Project
East West Rail (Western Section) Phase 2

Drawing Title
PASSING PLACE A3_P_5 GENERAL ARRANGEMENT

Stage 2 Road safety audit response report

Offline Highways Passing Places – Package 2 – Oxfordshire (A3 Marsh Gibbon – Compound Access)

Drawing Title
PASSING PLACE A3_P_5 EXISTING UTILITIES AND SITE CLEARANCE

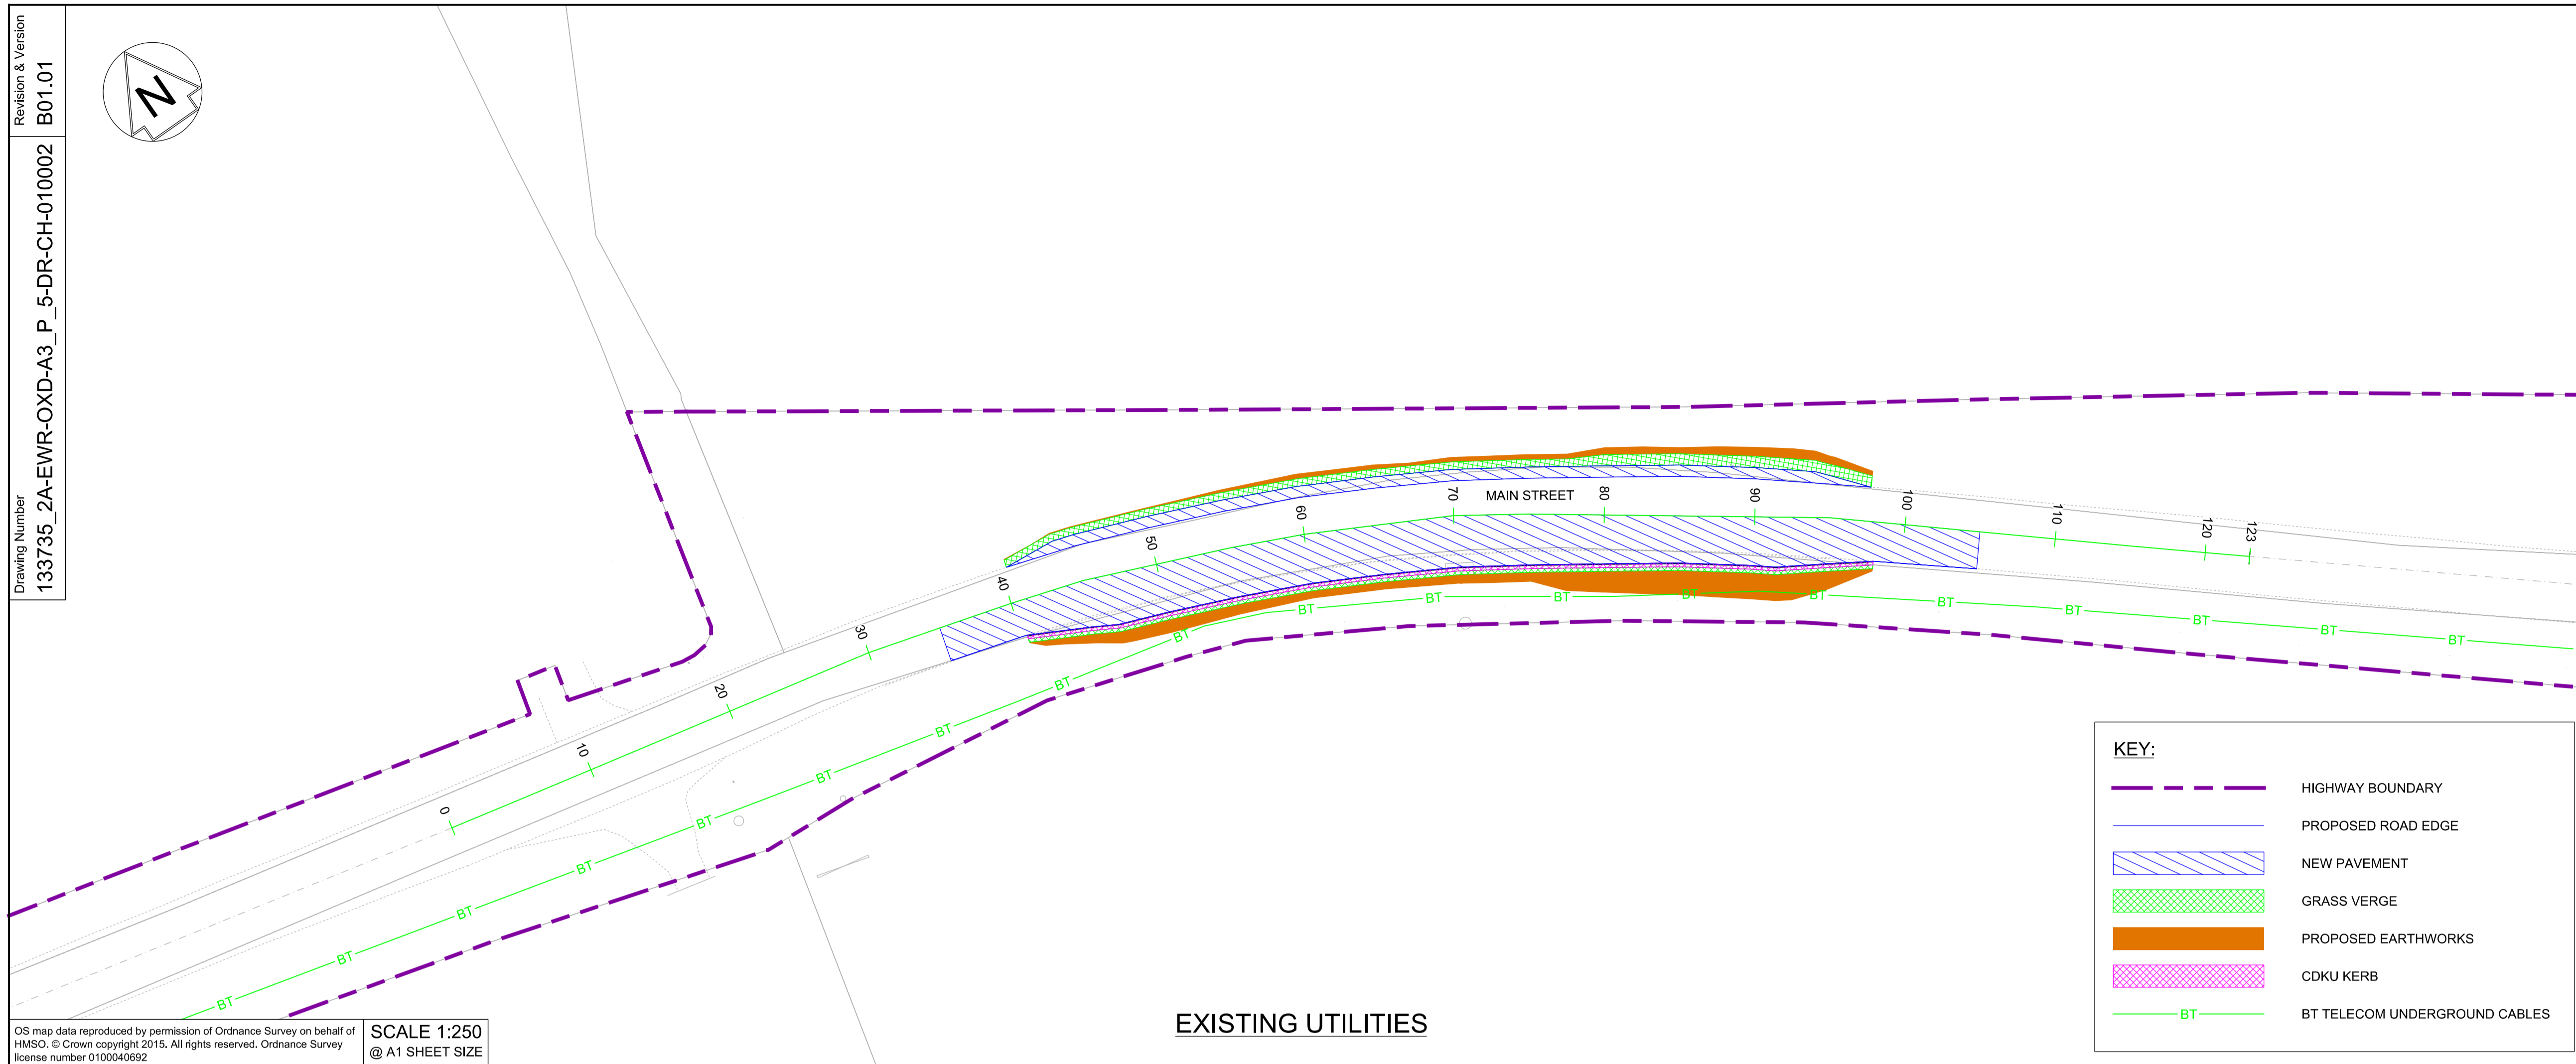
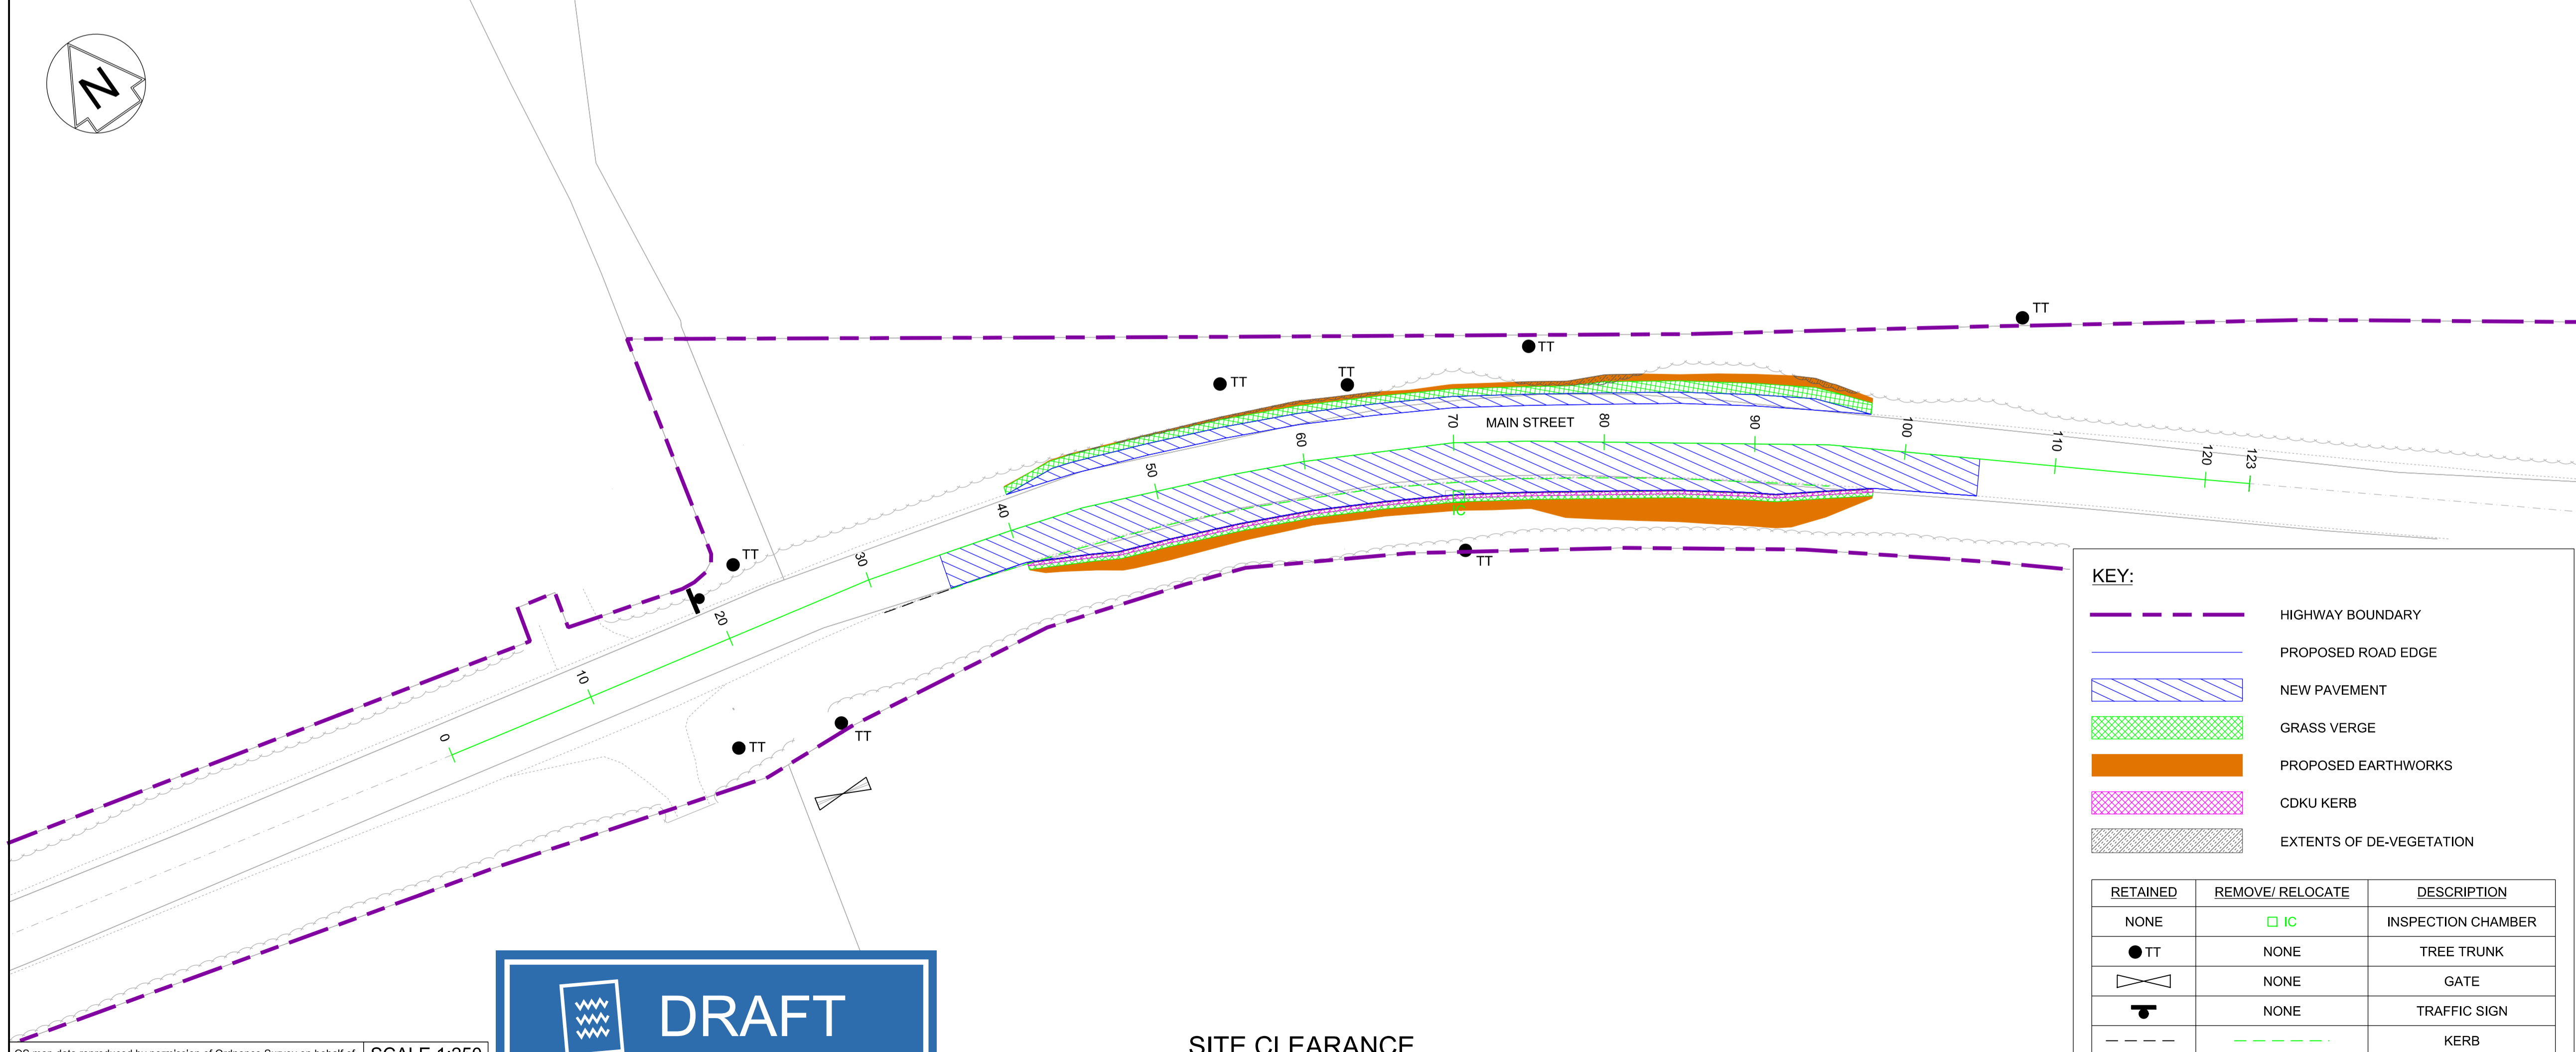
Location: Passing Places A3-P-2, A3-P-5 and A3-P-9.
Unnamed Road (towards Mill Road).

Summary: Proximity of passing place to public footpath access increases risk of pedestrian being struck by vehicle

A3-P-5, Unnamed Road (towards Mill Road) – Provide traffic signing to warn pedestrians and construction vehicles of the passing place and presence of pedestrians, respectively. Trim back vegetation around the access to maximise visibility between pedestrians and drivers; or

Remove passing place A3-P-5 (eastbound) as passing place A3-P-6 is adjacent.

PROBLEM 2.5

Summary: Driver visibility reduced by vegetation

Passing places are proposed in positions where vegetation may restrict drivers' visibility of the route and the visibility of vehicles using the passing places. With this limitation, drivers of construction vehicles may not be aware that they should wait and might proceed, increasing the risk of side swipe collisions, or the risk of vehicles leaving the carriageway

2.3	Passing Places A3-P-2, A3-P-5 and A3-P-9. Unnamed Road (towards Mill Road).	Proximity of passing place to public footpath access increases risk of pedestrian being struck by vehicle There are access to public footpaths directly from Unnamed Road (towards Mill Road) in the nearside verges just before the proposed passing places A3-P-2 and A3-P-5. The proposed location of passing place A3-P-9 is directly between the accesses to public footpaths on the north and south sides of Unnamed Road (towards Mill Road), with the passing place clashing with the access on the southern side. Due to the location of the passing places, there is an increased risk of a construction vehicle striking a pedestrian as they enter Unnamed Road (towards Mill Road), particularly as the construction vehicle will be preparing to enter the passing place. This issue is exacerbated by the lack of footway along Unnamed Road (towards Mill Road) as there is no segregation between vehicles and pedestrians.	A3-P-2, Unnamed Road (towards Mill Road) – Move passing place further downstream of public footpath access and provide traffic signing to warn pedestrians and construction vehicles of the passing place and presence of pedestrians, respectively. Trim back vegetation around the access to maximise visibility between pedestrians and drivers	Accept the RSA problem raised but suggest an alternative solution. Passing place to remain in proposed position in accordance with TWAO. Traffic signing to warn vehicles of the presence of pedestrians in advance of the public right of way interface shall be provided, on the northbound approach and before A3-P-2 and on the southbound approach and before A3-P-2. The site clearance drawings shall include vegetation clearance around the public right of way interface to maximise visibility for pedestrians and drivers. The RSA recommendations with respect to warning signage for pedestrians accessing the carriageway from a public right of way will be shared with the logistics team for inclusion.	Accepted	Proceed as Design Team Response

2.5	<p>Passing Places A2-P-2, A3-P-2, A3-P-3, A3-P-4, A3-P-5, A3-P-6, A3-P-7, A3-P-8, A3-P-9 and A3-P-10. Unnamed Road (towards Mill Road) and Unnamed Road.</p>	<p>Driver visibility reduced by vegetation Passing places are proposed in positions where vegetation may restrict drivers' visibility of the route and the visibility of vehicles using the passing places. With this limitation, drivers of construction vehicles may not be aware that they should wait and might proceed, increasing the risk of side swipe collisions, or the risk of vehicles leaving the carriageway on narrower sections of carriageway. Additionally, drivers of approaching vehicles may not anticipate the construction vehicle leaving the passing place, leading to side swipe or head on collisions. There is further risk that existing vegetation will encroach into the carriageway increasing the risk of damage to vehicles and HGVs being pushed towards oncoming traffic.</p>	<p>The existing vegetation should be cut back to ensure clear visibility to all traffic signs and to keep the carriageway clear from obstructions.</p>	<p>Accept the RSA problem and recommendation made by the RSA team. The site clearance drawings include vegetation clearance to achieve required visibility and signage strategy drawings likewise include this provision.</p>	Accepted	Proceed as Design Team Response

Drawing Title
SIGNAGE STRATEGY DRAWING FOR OXFORDSHIRE COUNTY COUNCIL

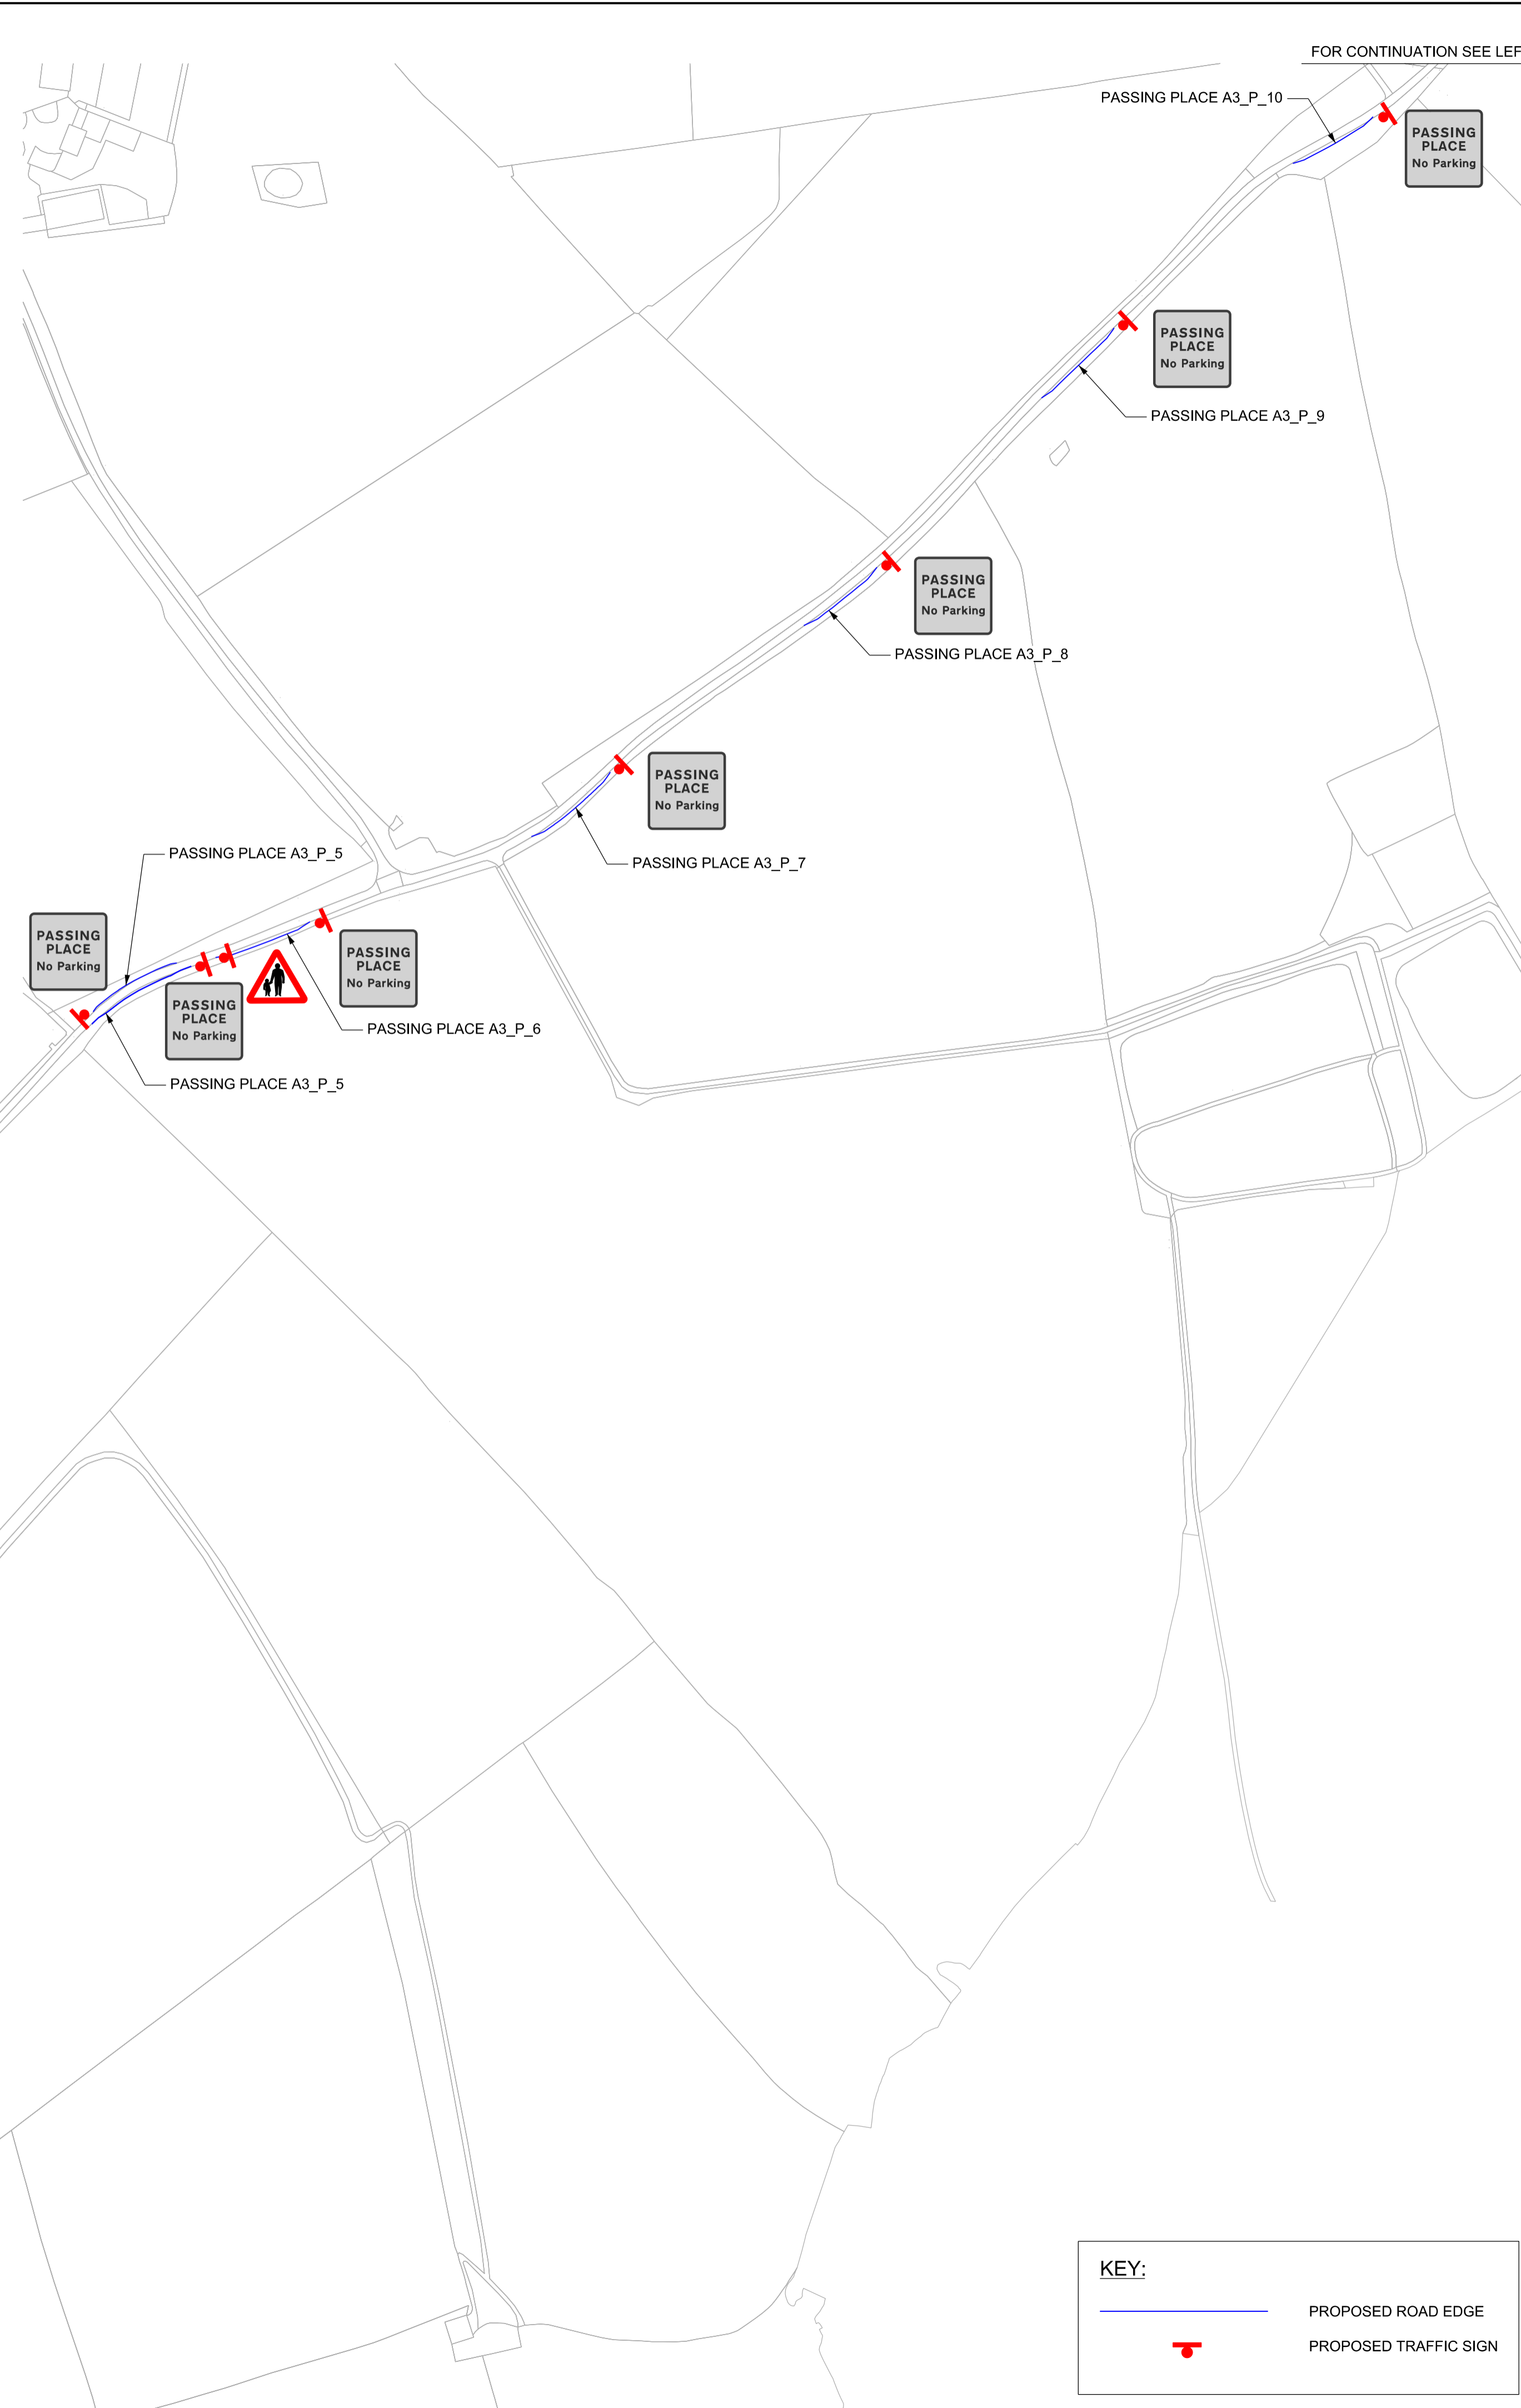
RECOMMENDATION

Provide traffic signing to warn of construction passing places and farm traffic accesses. Trim back vegetation around the accesses to maximise intervisibility.

RSA Ref	Location	RSA Problem	RSA Recommendation	Design Team Response	Network Rail Response	Agreed RSA action
2.4	<p>Passing Places A2-P-1, A3-P-2, A3-P-3, A3-P-5, A3-P-7 and A3-P-10. Unnamed Road (towards Mill Road) and Unnamed Road.</p>	<p>Proximity of passing place to farm traffic access increases risk of collision There are accesses used by farm traffic along the Unnamed Road (towards Mill Road). As a farm vehicle enters or exits these accesses from Unnamed Road (towards Mill Road), there is a likelihood that a construction vehicle may collide with it as they may not anticipate the turning farm vehicle, particularly when they are preparing to enter the passing place. This issue is exacerbated by the presence of vegetation around these accesses which reduces the visibility between farm traffic and construction drivers using the Unnamed Road (towards Mill Road).</p>	<p>Provide traffic signing to warn of construction passing places and farm traffic accesses. Trim back vegetation around the accesses to maximise intervisibility</p>	<p>Accept the RSA problem and recommendation made by the RSA team. The design includes a signage strategy which provides signs to notify drivers that the road has passing places. The site clearance drawings include vegetation clearance to achieve required visibility and signage strategy drawings likewise include this provision.</p>	Accepted	Proceed as Design Team Response
